**SUBJECT: JAMES A. FITZPATRICK NUCLEAR POWER PLANT – STAFF ASSESSMENT  
OF RESPONSE TO 10 CFR 50.54(f) INFORMATION REQUEST – FLOOD-  
CAUSING MECHANISM REEVALUATION (TAC NO. MF6106)**

STAFF ASSESSMENT BY THE OFFICE OF NUCLEAR REACTOR REGULATION

RELATED TO FLOODING HAZARD REEVALUATION REPORT

JAMES A. FITZPATRICK NUCLEAR POWER PLANT

**Figure 3.5-1. Wind-wave transects 1-5 and SWAN output locations (T1-T5) (adapted from FHRR unnumbered figure and FHRR Figure 3-44; locations are approximate); licensee determined that maximum combined flood hazard elevation location T5. (Base figure from Google Earth (Google Earth, n.d.))**

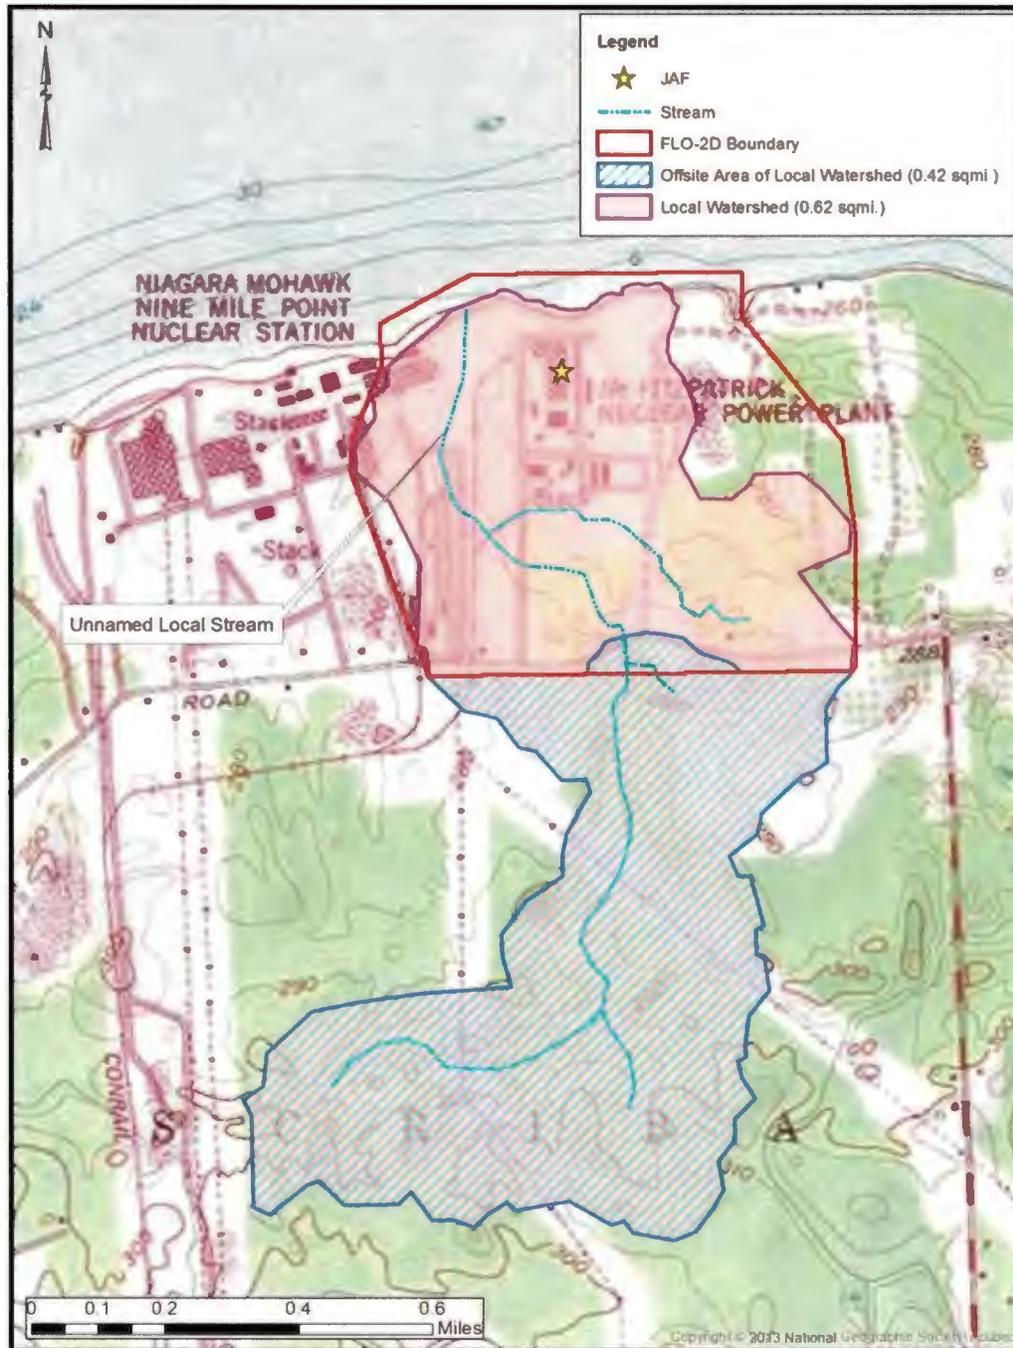
The licensee reported wave runup at FitzPatrick for both beaches (Transects 1 and 5) and cliff faces (Transects 2, 3 and 4) (Figure 3.5-1). The licensee reported a maximum run-up of 13.8 ft with a wave setup of 1.4 ft (at Transect 5). The licensee then stated that the maximum combined effects water elevation is 268.0 ft USLS35, which is about 4 ft below site grade.
